RE: Turkey Point Nuclear Plant, Units 3 and 4
Docket Nos. 50-250 and 50-251
Renewed Facility Operating Licenses DPR-31 and DPR-41

Supplement to Updated Final Response to NRC Generic Letter 2004-02

Supplement to Updated Final Response to NRC Generic Letter 2004-02

Figure E1-1: DCPD Test Strainer General Arrangement

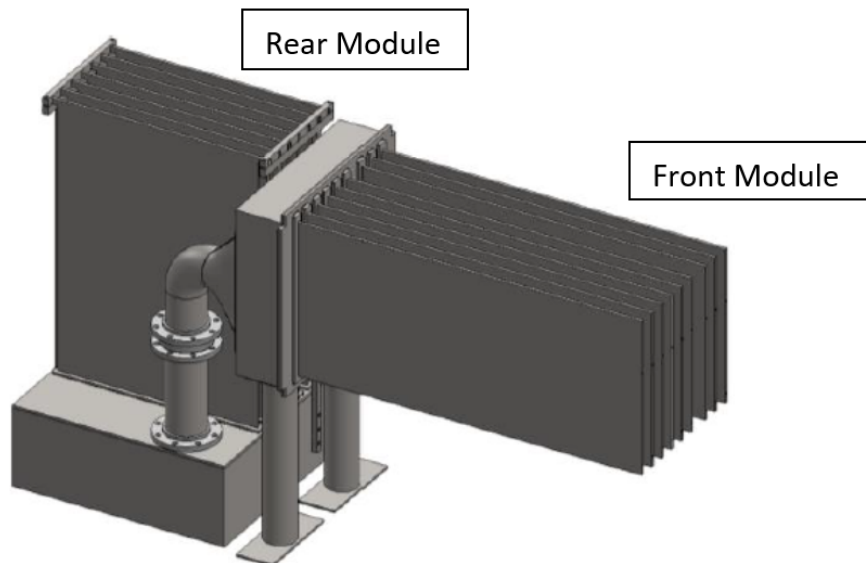
During the Nuclear Regulatory Commission's (NRC) audit of the Turkey Point (PTN) Generic Letter (GL) 2004-02 submittal (Ref. 1), a concern was raised about using average approach velocities when comparing vortexing data from the St. Lucie Unit 1 (PSL-1) test strainer with the PTN Unit 3 (PTN-3) plant strainer (Ref. 2).

Due to the similarity in physical design, the Froude number and vortexing performance of the front module of the DCPD test strainer is compared against the data from PTN-3's maximum approach velocity strainer module. Figure E1-1 shows the arrangement of the DCPD test strainer.

The key parameters of the vortex testing of the front module of the DCPD test strainer are shown below in Table E1-2.

The dimensionless Froude number for the front test strainer module at DCPD can be calculated as shown below:

$$F_r = \frac{0.00523}{\sqrt{32.2 \times 0.306}} = 0.00167$$

As seen in the DCPD Head Loss Technical Report, no substantial vortex formation was observed in the test loop throughout the vortex testing. No air entrainment from the strainer

assembly was observed even when the strainer submergence was further reduced, uncovering the rear strainer disk support cross-members. Accounting for this reduction in submergence, the maximum tested Froude number during the DCPD vortexing testing was:

$$F_r = \frac{0.00523}{\sqrt{32.2 \times 0.2725}} = 0.00177$$

This Froude Number is less than but at the same order of magnitude as that of the PTN-3 strainer.
